19 January 2021

2190947

**Response to Further Agency, Organisation and Public Submissions  
Powerhouse Parramatta – SSD 10416**

**DA200**

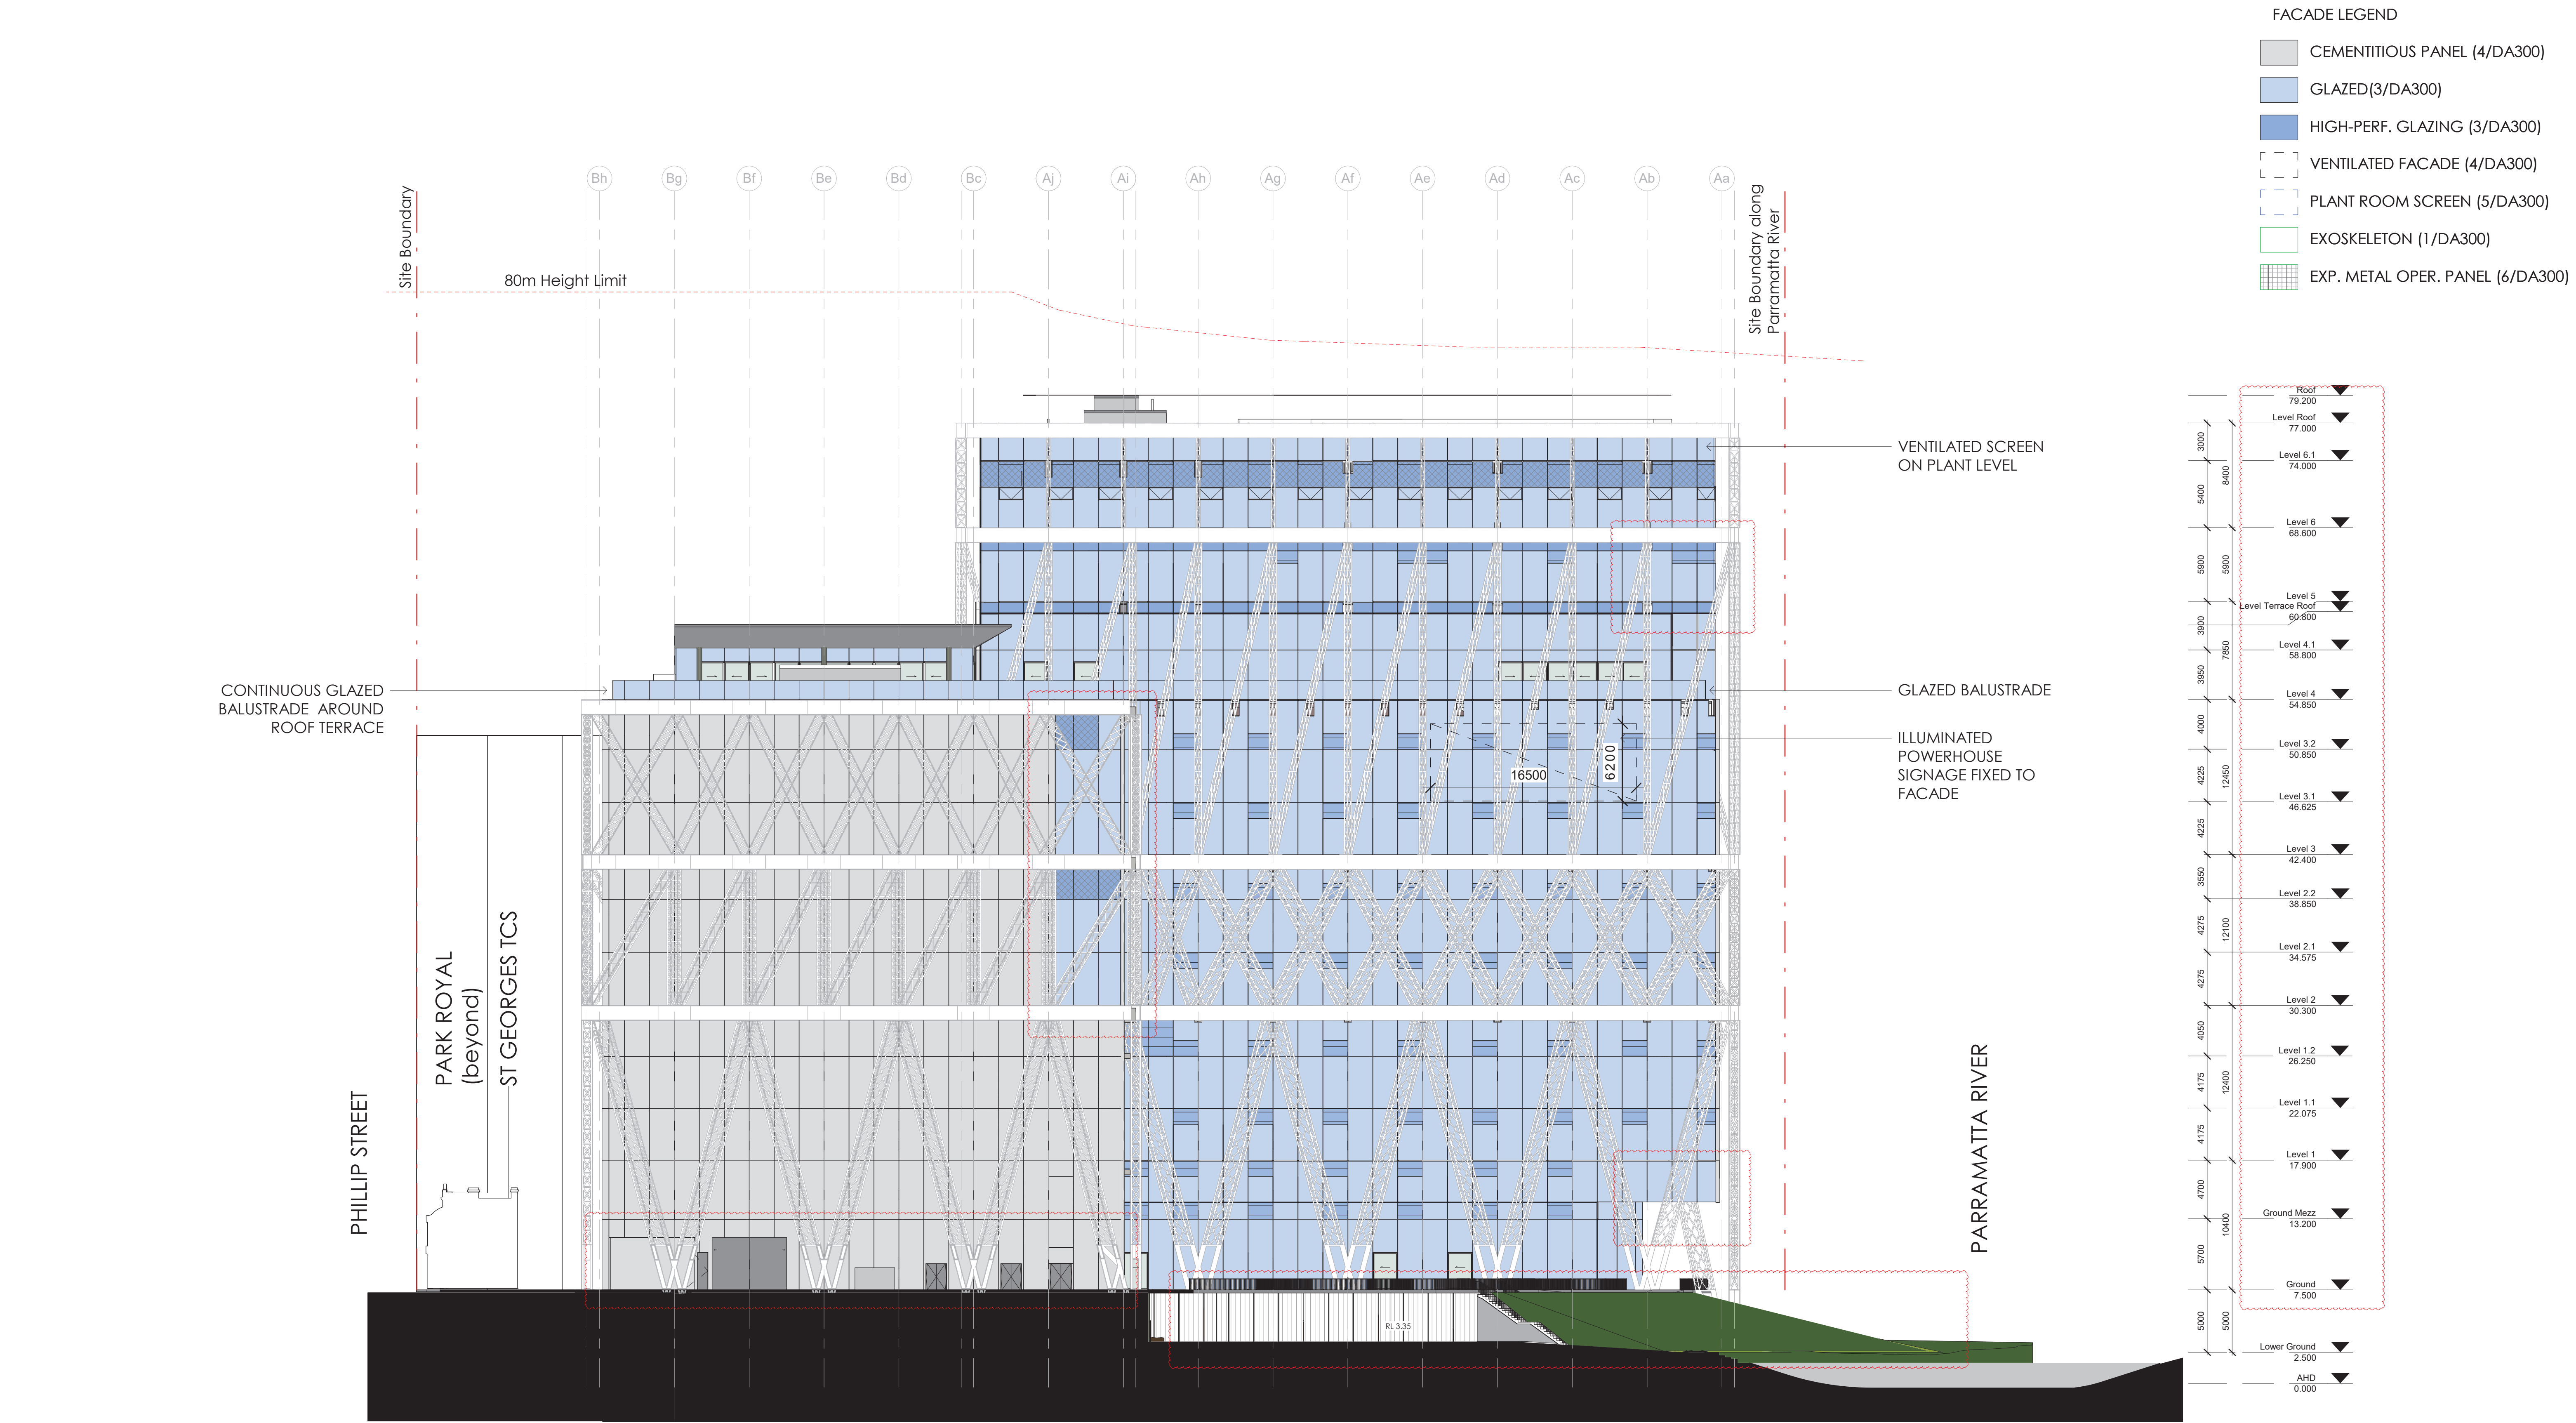
No.	Extract	Comment																								
DPIE15	<ul style="list-style-type: none"><li>Drawing DA200 - the revision number cited in the drawing 'Revision' and 'Revision History' are inconsistent.</li></ul>	An updated Drawing DA200 is provided at <b>Attachment 2</b> .																								
DPIE16	<ul style="list-style-type: none"><li>Confirm the site address including Lot and DP numbers. In particular, the Department notes the following inconsistencies:<ul style="list-style-type: none"><li>EIS page 6 states 30B, 34-54 Phillip Street and 338 Church Street</li><li>EIS page 26 states 30B, 34, 40, 42 and 44-54 Phillip Street, 338 Church Street nos. 36-38 (two storey buildings fronting Phillip St next to Willow Grove) are not cited.</li></ul></li></ul>	<div><div>The following legal descriptions apply, and a summary of street addresses for the applicable lot and DP references. The Applicant notes that there is variance within property databases regarding the street addresses for the Lot. Street addresses from Six Maps and the Planning Portal have been utilised:</div>
